## Safe and Healthy Streets Consultation - Bucknall Street area

This response to the consultation on the above proposal is from Camden Cycling Campaign, the local borough group of London Cycling Campaign. We represent the interests of cyclists living or working in or travelling through Camden and aim to expand the opportunities for all to cycle safely in the borough.

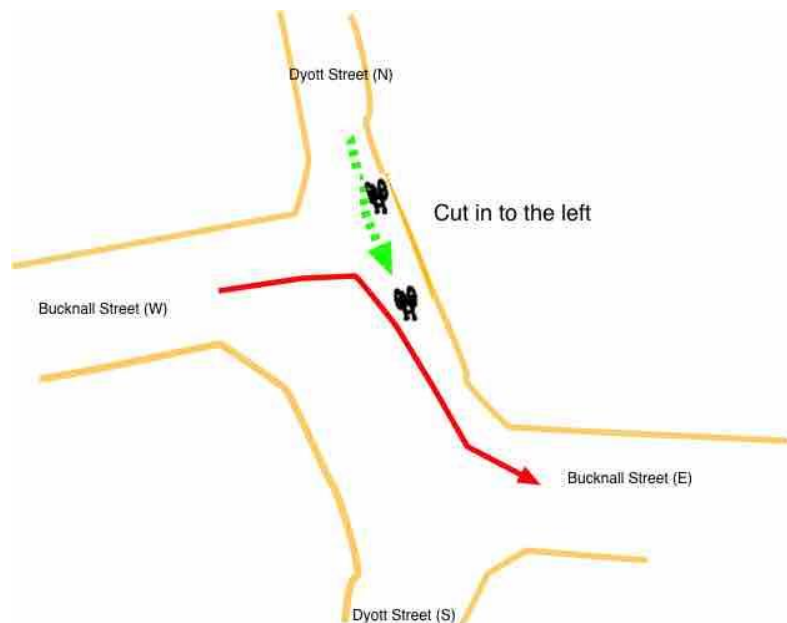
The junction where Bucknall Street crosses Dyott Street needs careful consideration: northbound motor vehicles on Dyott Street and eastbound motors on Bucknall Street (west) will be heading for Bucknall Street (east) while cycles can make all possible manoeuvres through the junction. We are particularly concerned about the following potential collisions:

1. Southbound cyclists on Dyott Street (north) may come into conflict with motor vehicles:
  - a. coming out of Bucknall Street (west) – see diagram
  - b. turning right out of Dyott Street (south) across the cyclists' path.

Southbound cyclists on Dyott Street (north) should have a clearly marked Give Way.

Considering (a): the line of logos on Dyott Street shown on the scheme drawing should be emphasised by a white mandatory cycle lane
